**REPORT TO GEORGES RIVER COUNCIL
IHAP MEETING OF 27 October 2016**

IHAP Report No	3	Development Application No	DA2016/0075
Site Address & Ward Locality	399-403 Princes Highway, Carlton Kogarah Bay Ward		
Proposal	Demolition of existing buildings and construction of a five (5) storey residential flat building with basement car parking and strata subdivision		
Report Author/s	Greg Hansell – Senior Planner		
Zoning:	R3 Medium Density Residential		
Date of Lodgement	28 April 2016		
Owner	Hwyflora Pty Ltd		
Applicant	Mr M Murr		
Submissions	20 submissions of objection		
Cost of Works	\$4,400,000.00		
Issues	Deferred by the IHAP at the meeting held on 8 September 2016		
Recommendation	That the Panel receive and note the amended plans and information and resolve whether they satisfactorily address their concerns raised at the meeting on 8 September 2016 to enable consent to be granted in accordance with the conditions of the original report as subsequently amended.

Site Plan

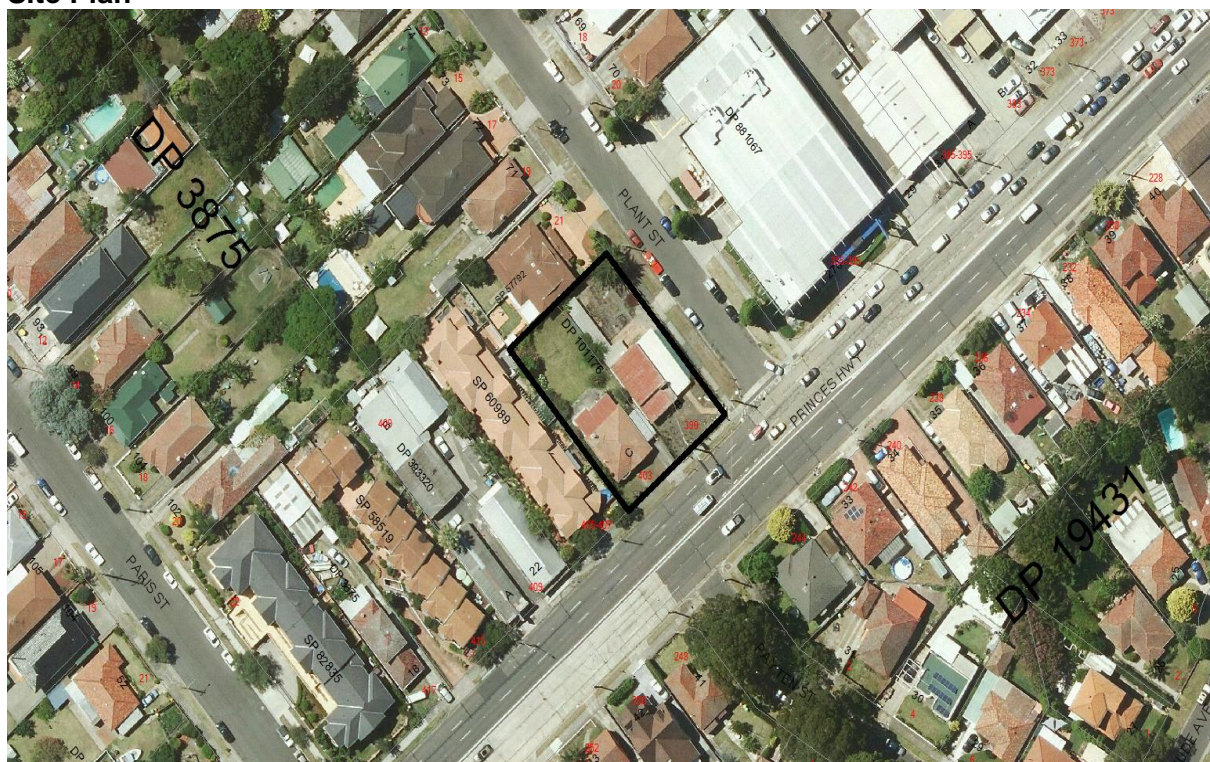
The Georges River Council IHAP as the delegate of the Georges River Council defers determination of Development Application No. 2016/0075 for the demolition of existing buildings and construction of five (5) storey residential flat building with basement car parking and strata subdivision at 399-403 Princes Highway, Carlton and invites the applicant to submit amended plans for consideration at a future meeting of the IHAP showing:

- *The maximum height of the development with the lift overrun including the RL to the top of the building*
 - *Relocation of the bin storage area so that it is directly accessible from the lobby and not proximate to the adjacent neighbour to the north*

- *High level sill windows on the north elevation adjacent to the living area for Unit U09*
 - *Landscape plans that are consistent with the architectural plans*

- *Floor to floor heights of not less than 3m*
 - *Deletion of the walls dividing the balconies of Unit U02, U03, U07, U08, U11, U12, U18, and U19*
 - *The location of the garage door in section*

- *The location of plant and air conditioning units*
 - *The location of columns in the basement car park*
 - *Removal of the wall blocking the doorway to Unit 22*

4. The amended architectural plans include maximum height dimensions inclusive of the lift overrun and reduced levels on the rooftop of the building including the lift overrun, rooftop lift lobby, rooftop terrace balustrades and main rooflines. The lift overrun raises the overall maximum height of the building by 2.2m to 19.97m. These details are indicated on the elevation and section drawings.
 - ***Relocation of the bin storage area so that it is directly accessible from the lobby and not proximate to the adjacent neighbour to the north***

5. The amended architectural plans include the relocation of the bin storage area so that it is sited adjacent to the pedestrian pathway between the main lobby and Plant Street and well away from the north western boundary abutting the dual occupancy at No. 21 Plant Street. The bin storage area is now directly accessible from the lobby. Council's Waste services officer is also satisfied with the location and size of the bin storage area.

6. The amended architectural plans include the modification of the two (2) windows concerned such that they have lower sills set at 1.6m above the respective floor level. These details are indicated on the northwest elevation drawing.

7. The landscape plans have been updated to be consistent with the latest architectural plans. These plans include tree planting comprising four (4) trees distributed equally along both street frontages. The relocation of the bin storage area has resulted in the removal of the pathway adjacent to 21 Plant Street and increased screen planting opportunities along the north western side boundary of the site. The bin storage area is screened from Plant Street by proposed hedge planting.

9. The amended architectural plans include the modification of the floor to floor heights such that they are 3m on each apartment floor level. These details are indicated on the section and elevation drawings.

10. The amended architectural plans include the deletion of the walls dividing these balconies.

11. The amended architectural plans include a section drawing showing the location of the garage door along the internal driveway to the basement. The podium slab has been extended and stepped upwards over the lower end of the driveway ramp so as to accommodate the garage door. The garage door is recessed 1.6m inside the outer edge of the podium slab above the driveway. No issues are raised by council's traffic engineer with regard to the design of the driveway access taking into account the garage door.

12. The amended architectural plans include details of the future location of individual air conditioning units on balconies, together with additional plant rooms within both basement car park levels.

13. The amended architectural plans include details of the location of columns in the basement car park levels. No issues are raised by council's traffic engineer with regard to the design of the car park taking into account these columns.

14. The amended architectural plans include the removal of the wall concerned.
